## **ADDENDUM NO. 2**

Date: May 23, 2018

**Project: Hiram Johnson HVAC Replacement**

E2.04

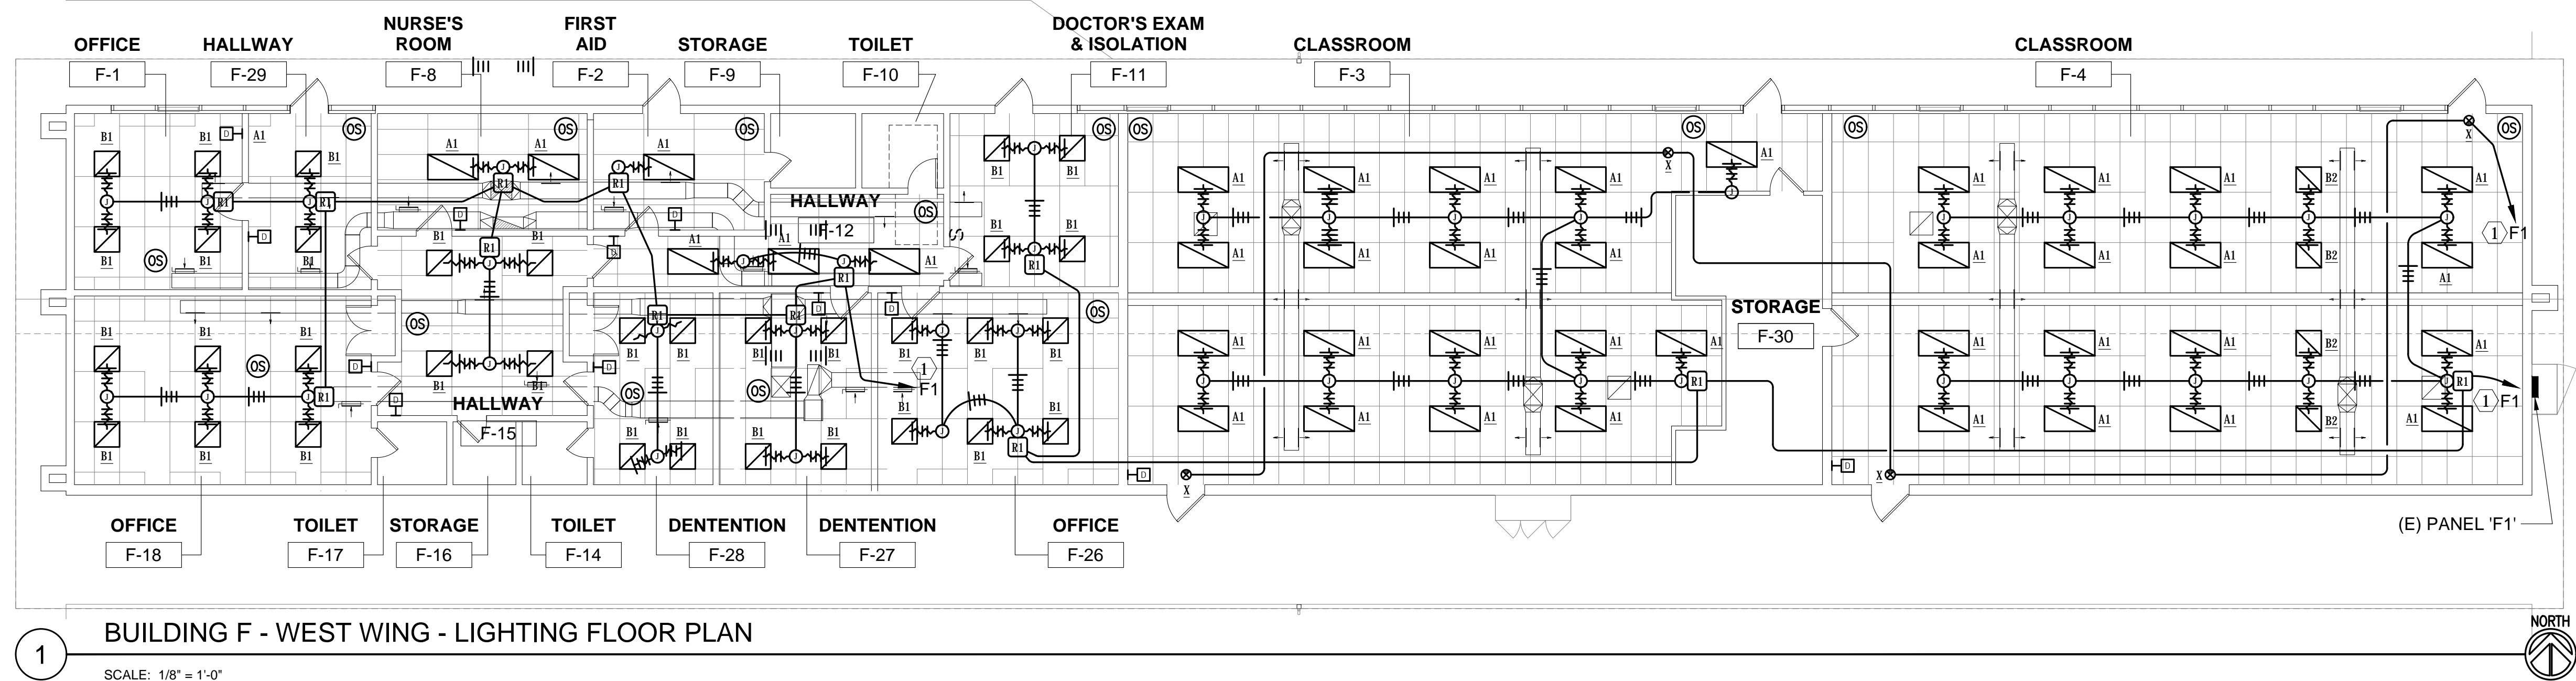
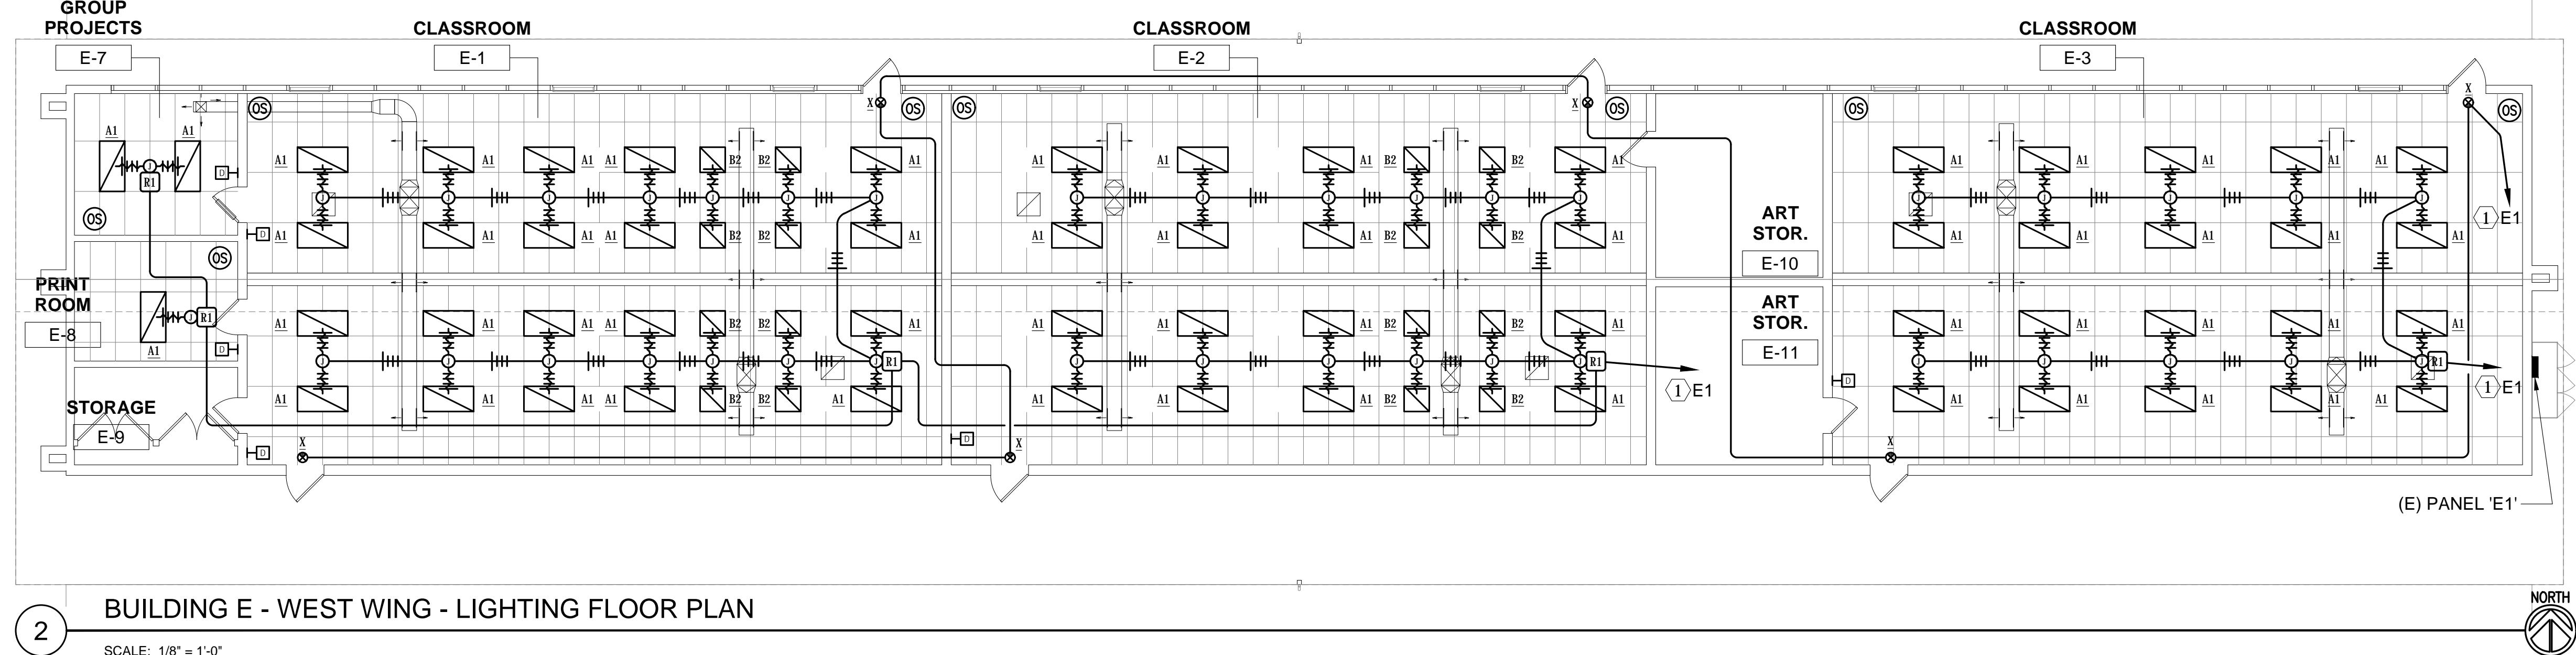
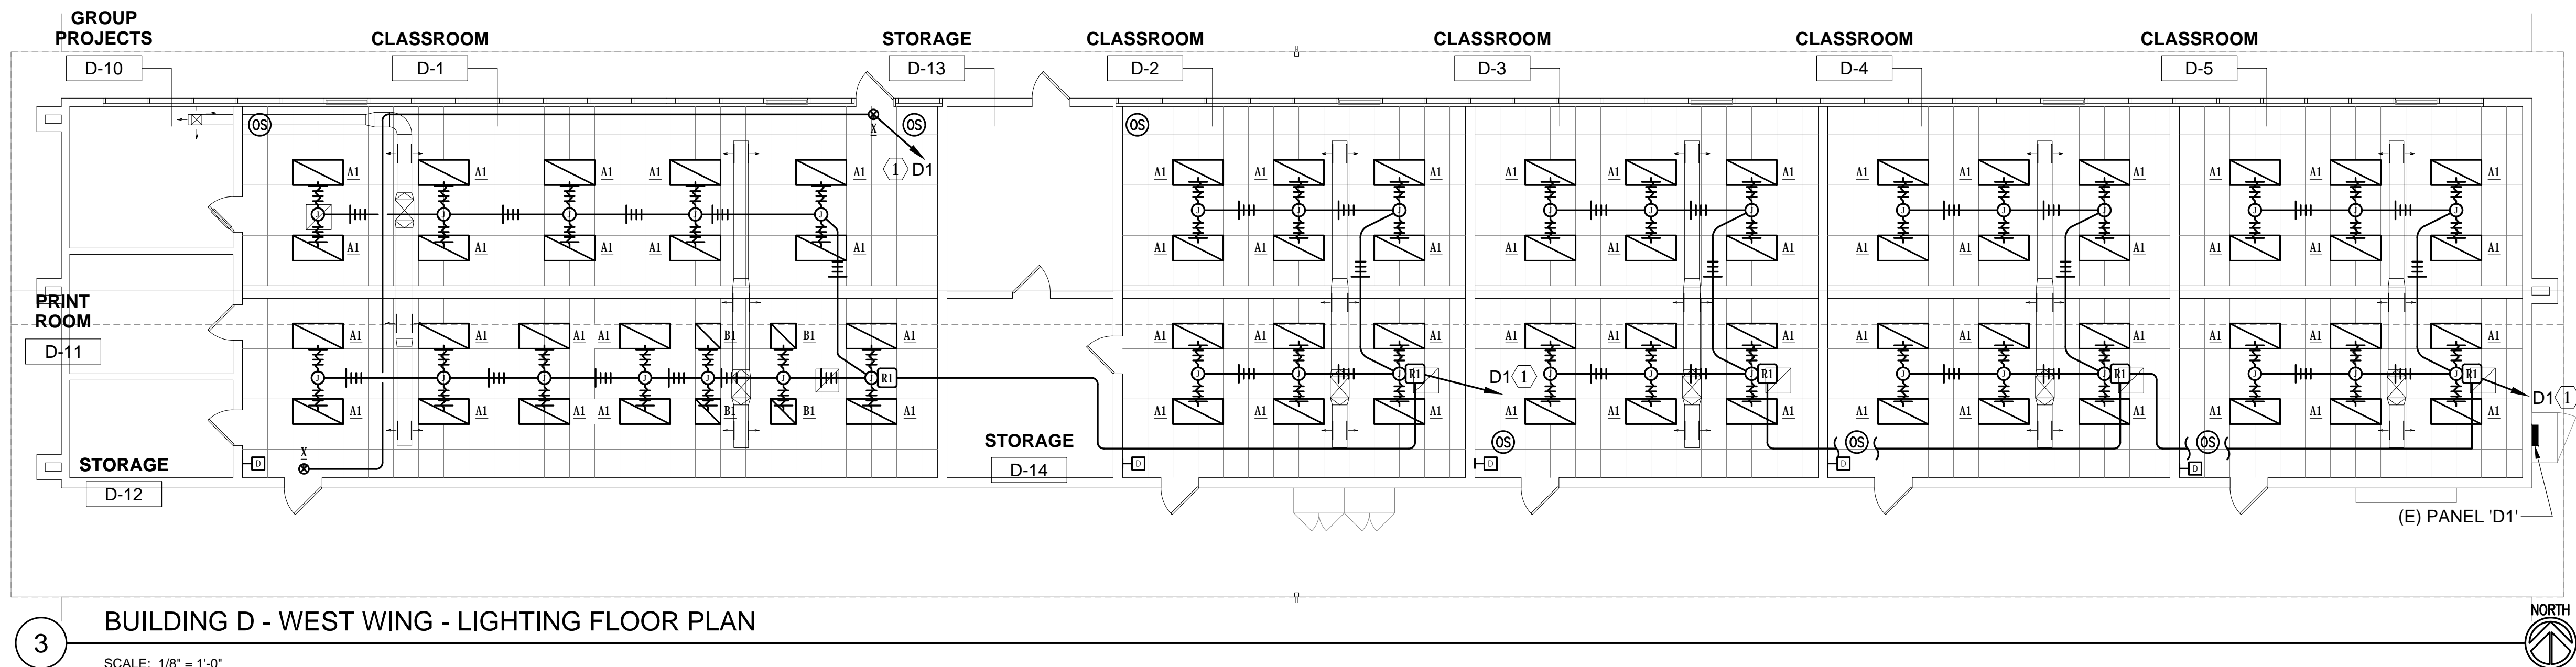
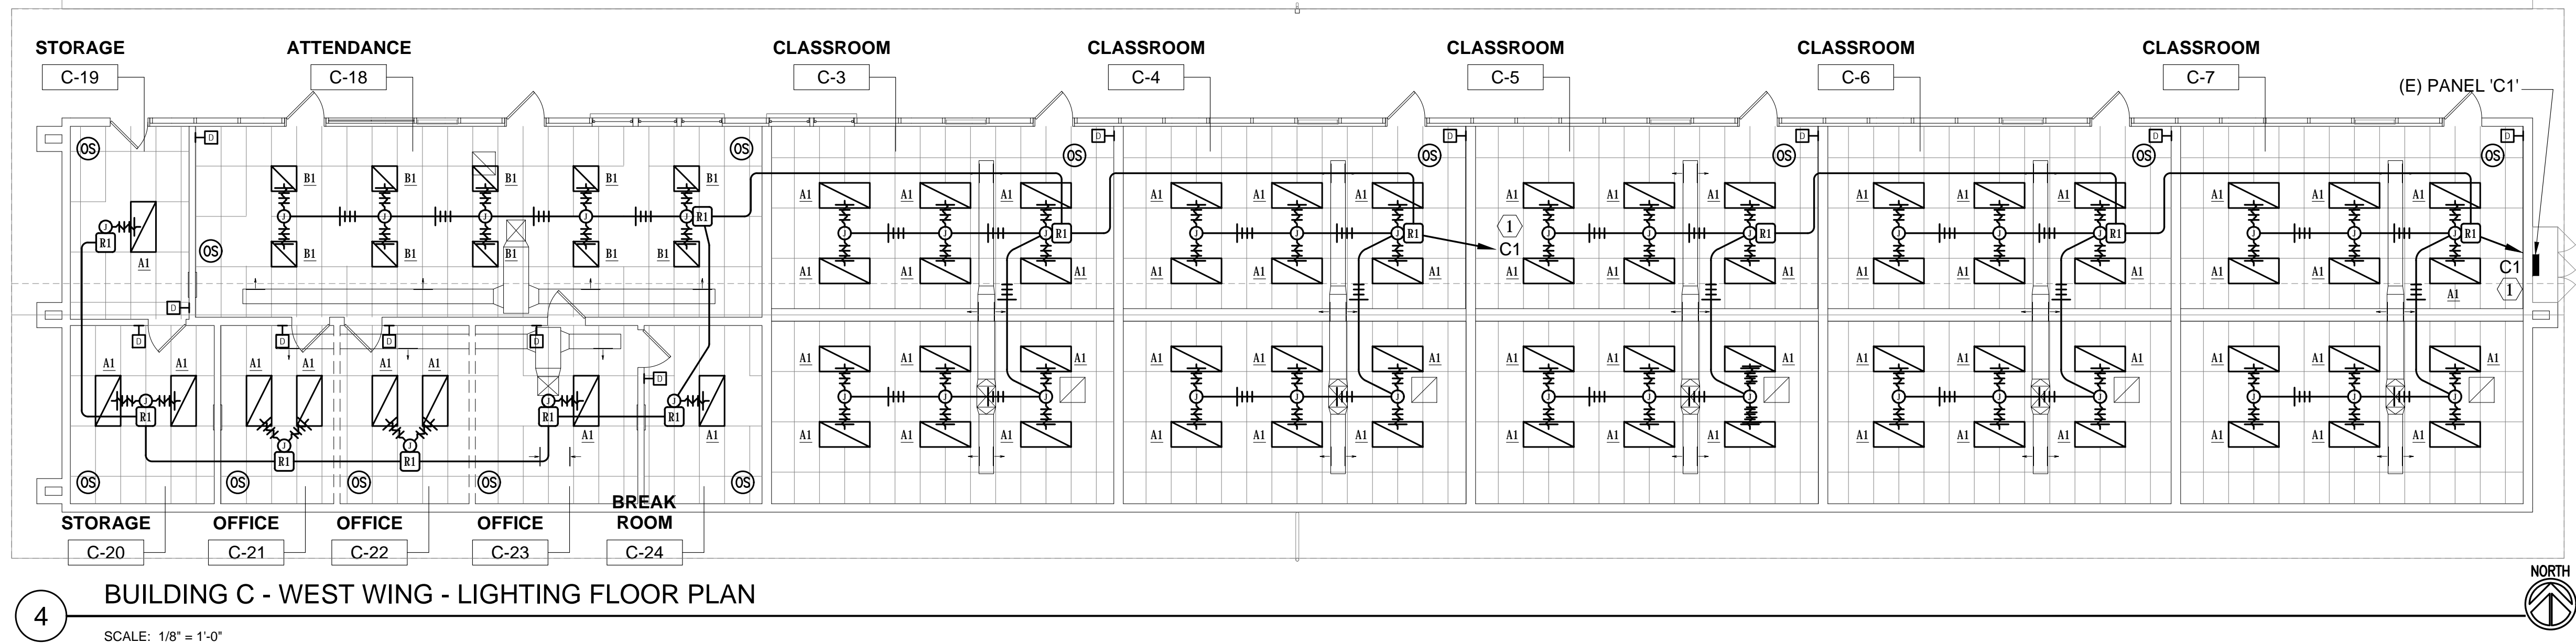
**Refer to Drawing Sheet E2.04**

**Note:** Entire sheet adds lighting demolition scope.

Client Project Number:	Client Proj. #
Scale: As indicated	Sheet
Drawn By: Chris	E3.11
Checked By: Donny	
Issue Date: 4/17/18	
Revit Version: 2017

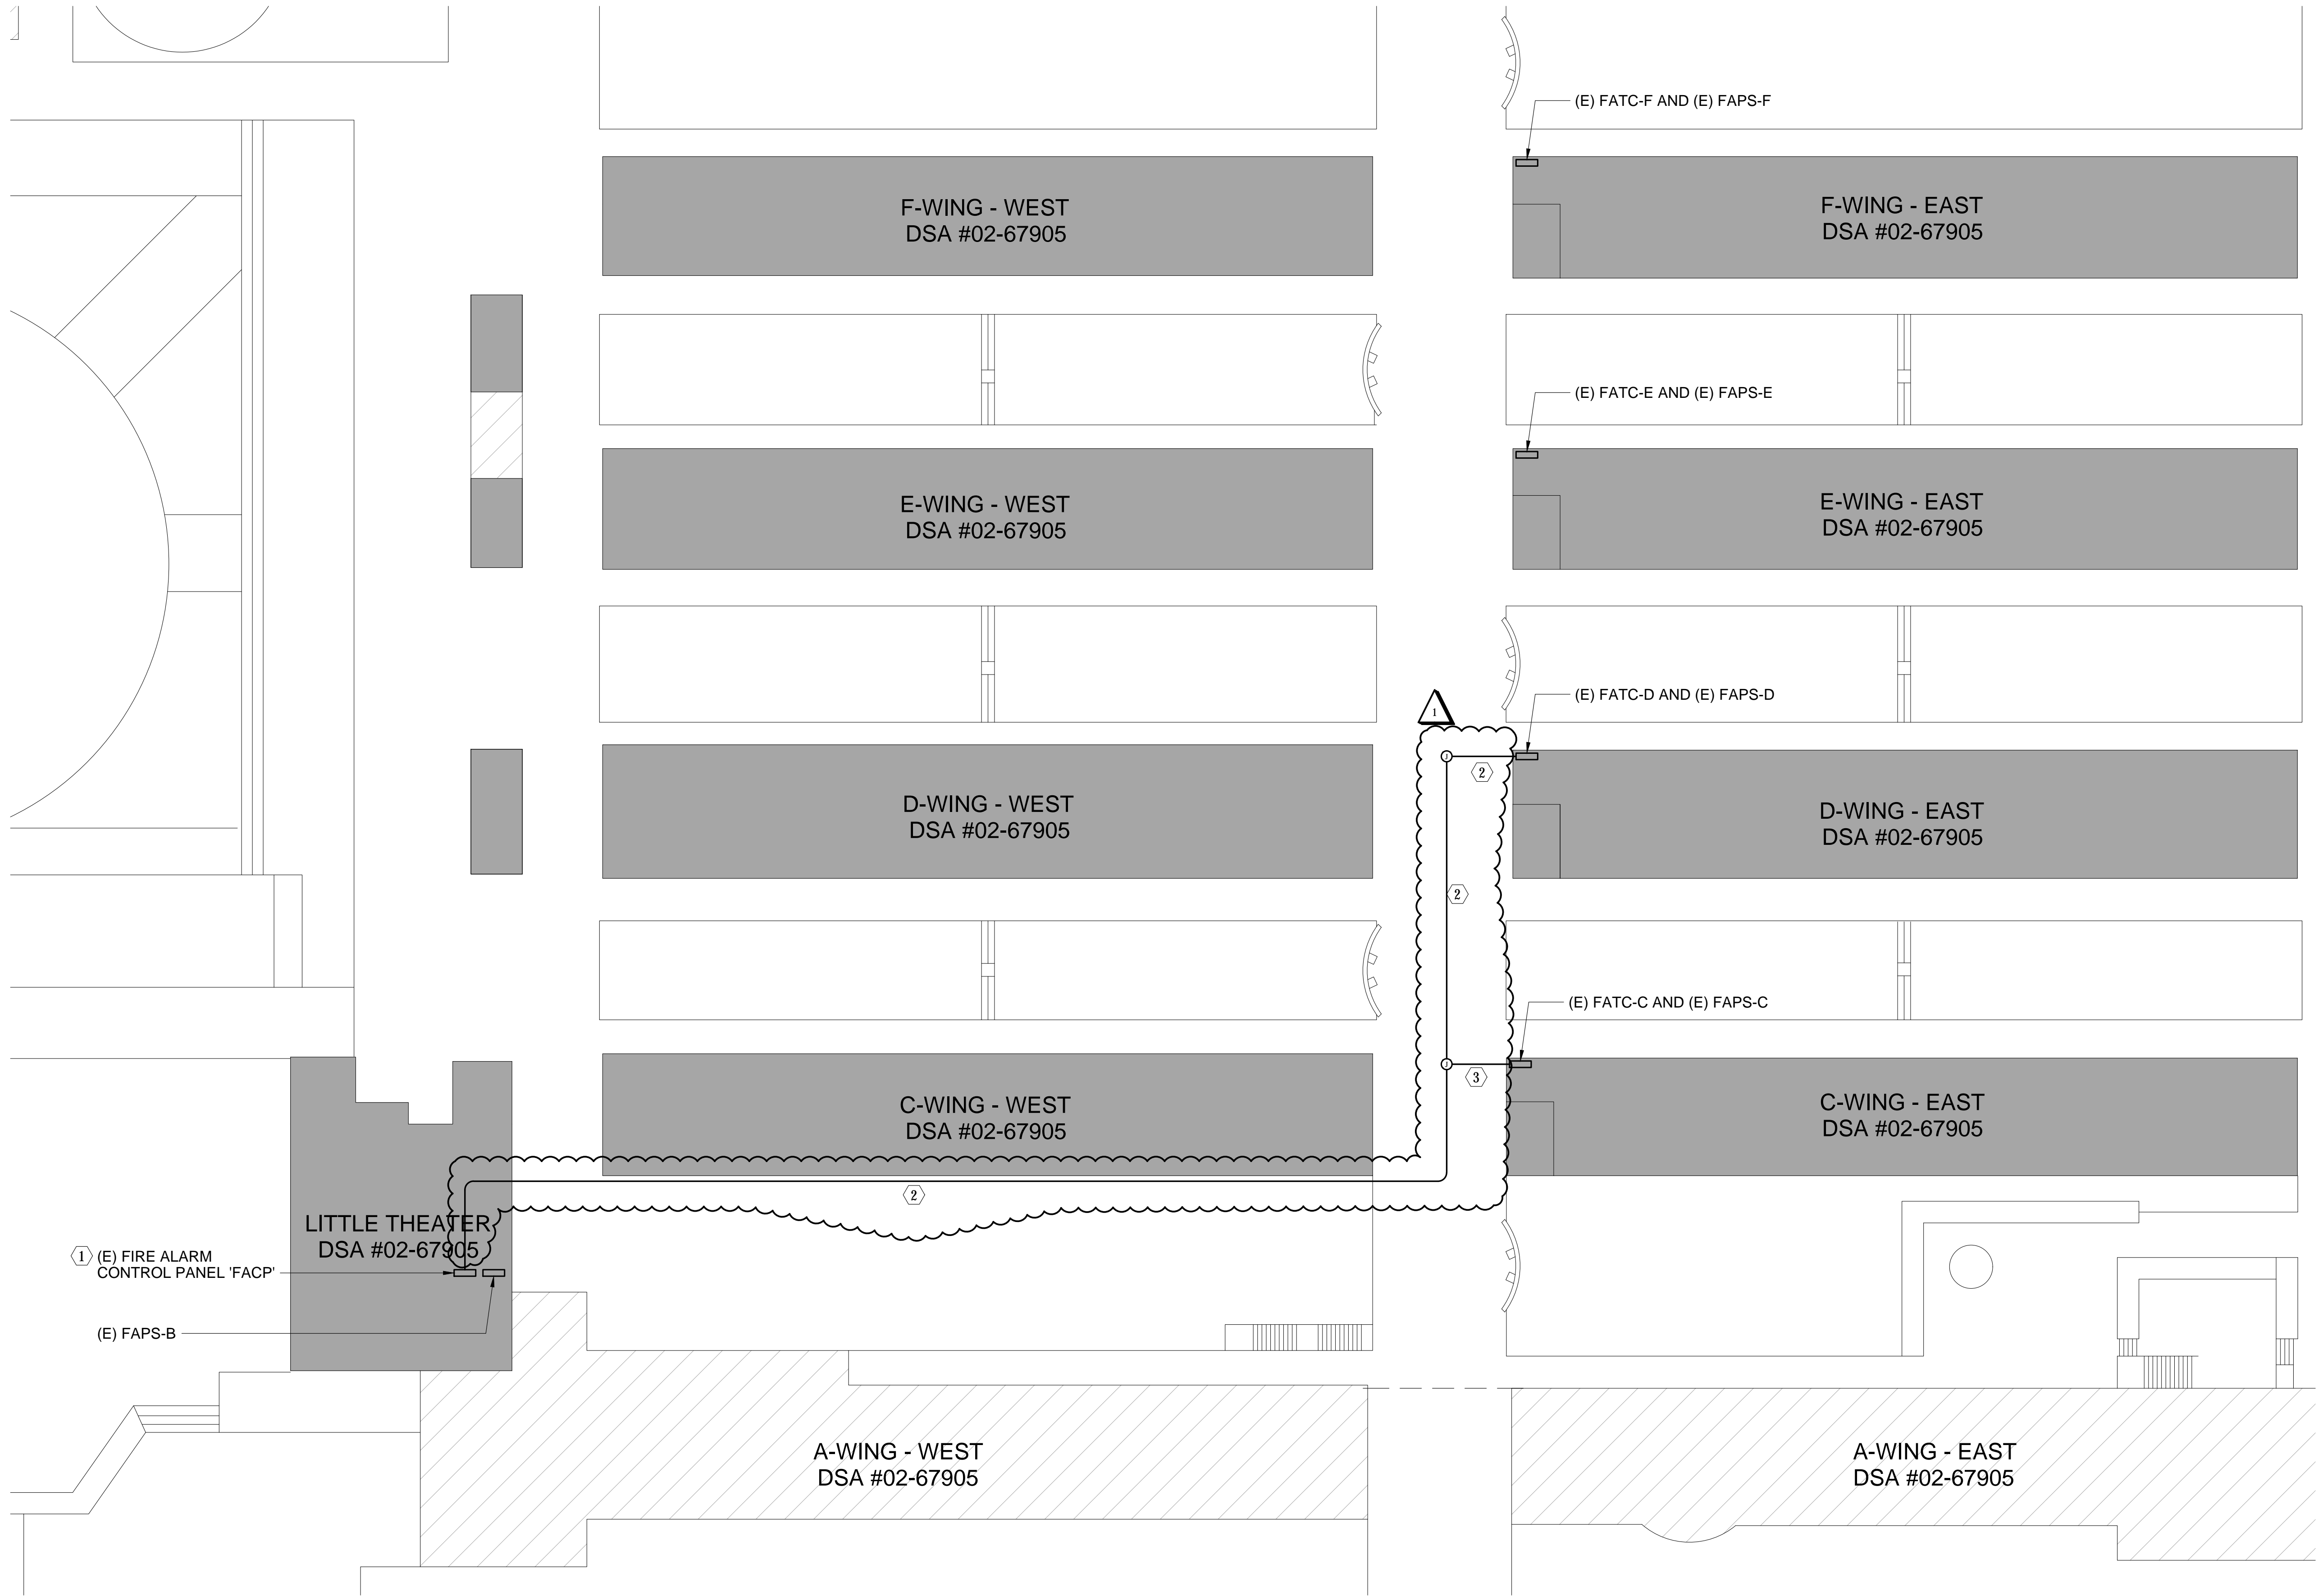
**Refer to Drawing Sheet E3.1.1**

**Note:** Clouded areas show additional site fire alarm conduit and wiring.
